Langstone Stakeholder Working Group (5) Monday 4th July 2022

SUMMARY OF RESPONSES – BREAKOUT SESSION

Flood Gates

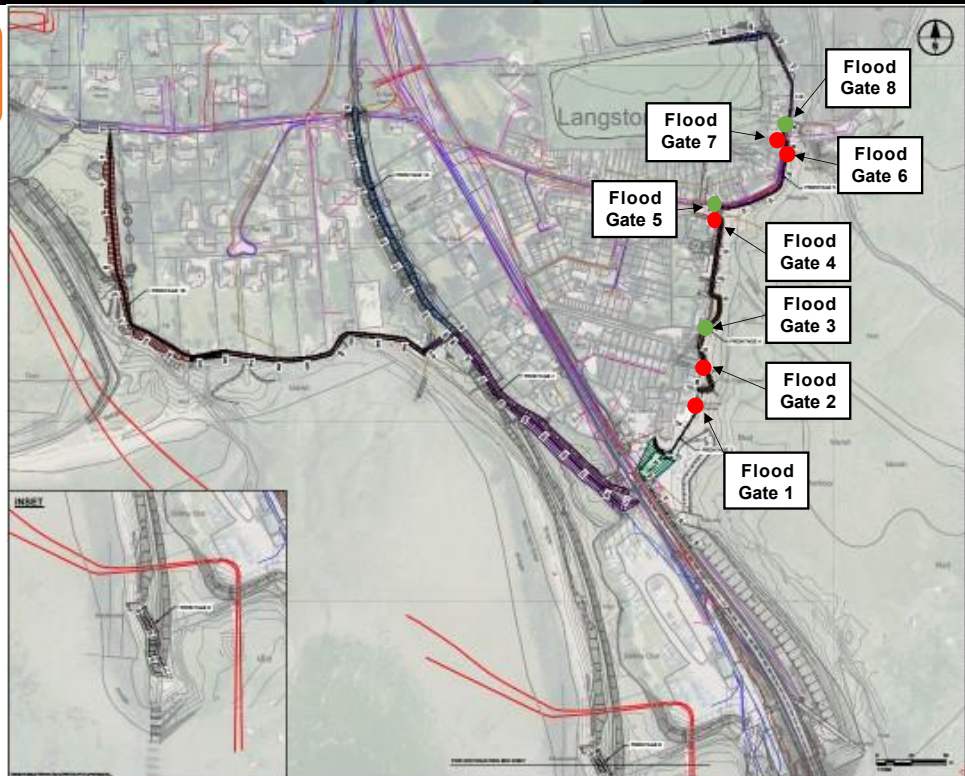
- Cladding – timber (x11) - light oak version, darker timber, durable timber
- Glass top (x2)
- No Cladding (x0) –plain steel wouldn't suit Langstone
